To: Seguin Planning & Zoning Commission
From: Kyle Warren, Planner
Subject: Greenspoint Heights Unit 3B
Date: February 29, 2024

FINAL PLAT ESTABLISHING GREENSPPOINT HEIGHTS, UNIT 3B

BEING A 10.38 ACRE TRACT OF LAND SITUATED IN THE JOHN D. CLEMENTS SURVEY,
ABSTRACT NO. 11, GUADALUPE COUNTY, TEXAS. BEING A PORTION OF A 214.411
ACRE TRACT RECORDED IN DOCUMENT NO. 2018-99023476, OFFICIAL PUBLIC
RECORDS, GUADALUPE COUNTY, TEXAS.

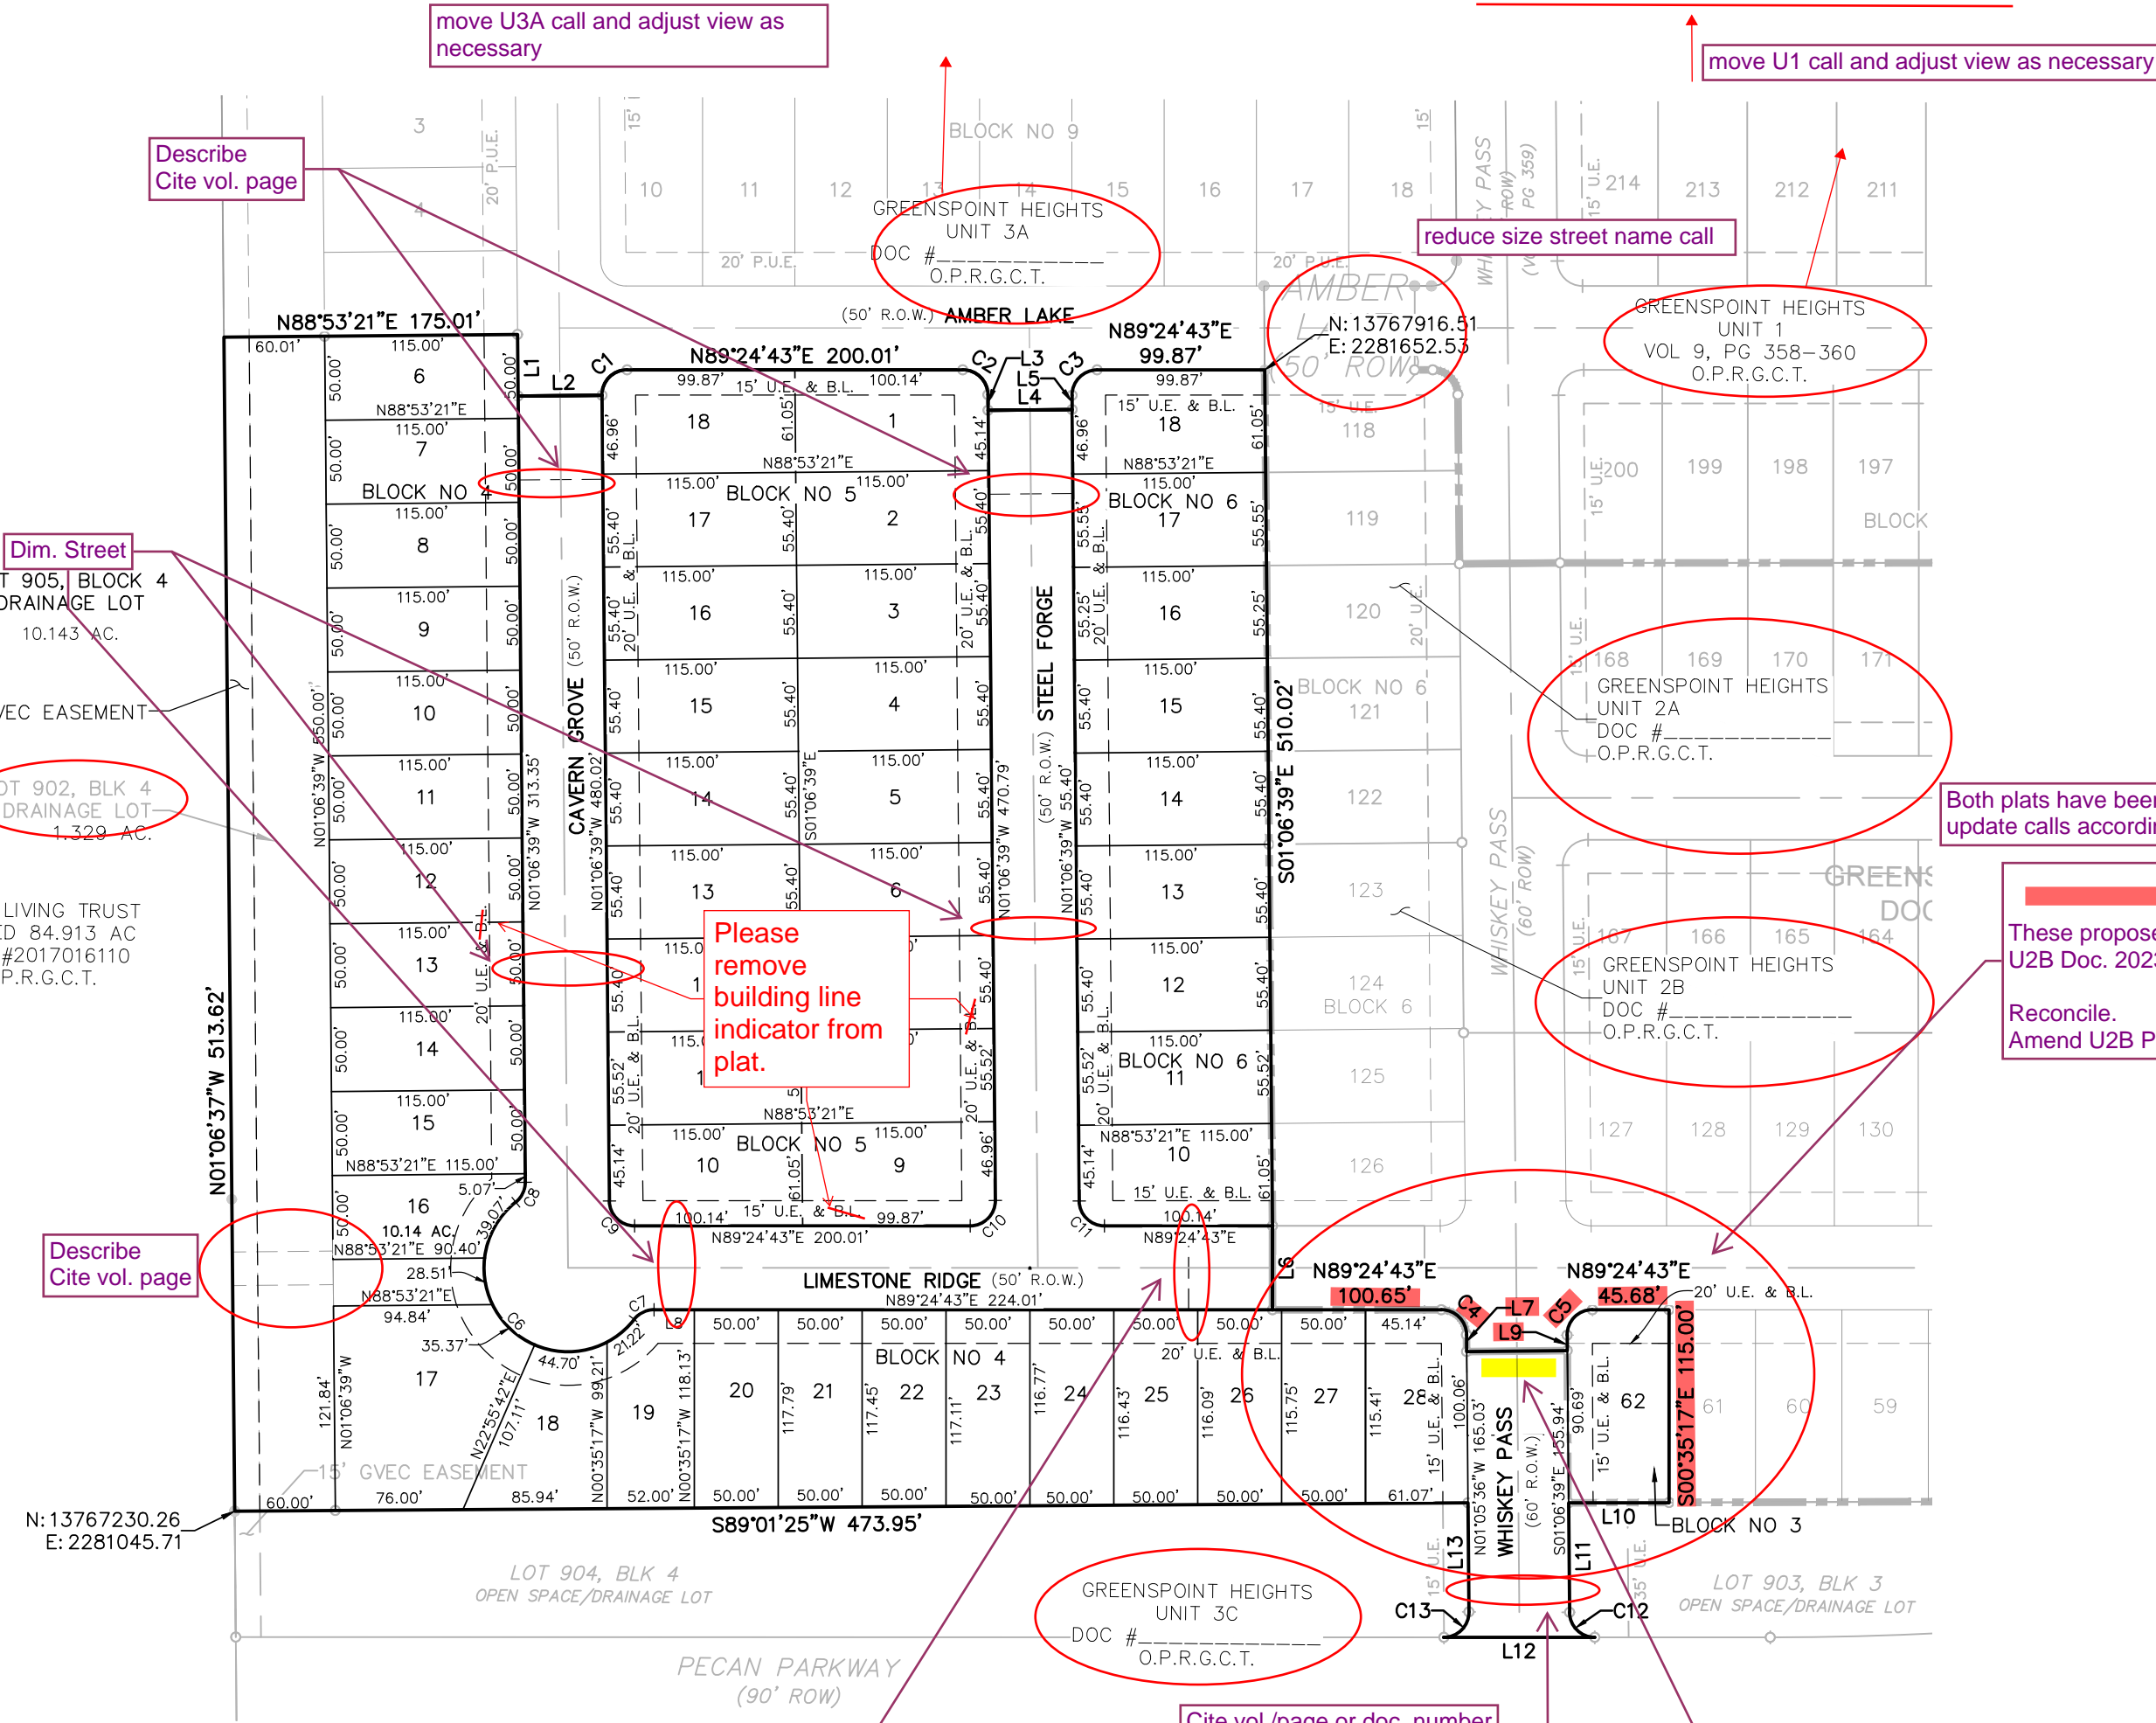
Do not greyscale Lot call. This lot is being created herein, correct?

Dim. Street

Describe Cite vol. page

Please remove building line indicator from plat.

Cite vol./page or doc. number

Describe Cite vol. page

Dim. Street

Add L14 Yes, We recognize that this boundary line will be vacated after recodation of 3B, but this is the mess created by HMT's phasing plan.

The Unit 3B Plat shall not be recorded until Unit 3C public improvements, included master development SWMP, are constructed and accepted for use.

Bonding of Public Improvements to record the Greenspoint U3B Plat will result in a hold on release of addresses and/or building permits.

Both plats have been recorded. update calls accordingly.

These proposed calls do not match recorded U2B Doc. 202399028112. Reconcile. Amend U2B Plat as required.

Update
PLAT PREPARED OCTOBER 11, 2023
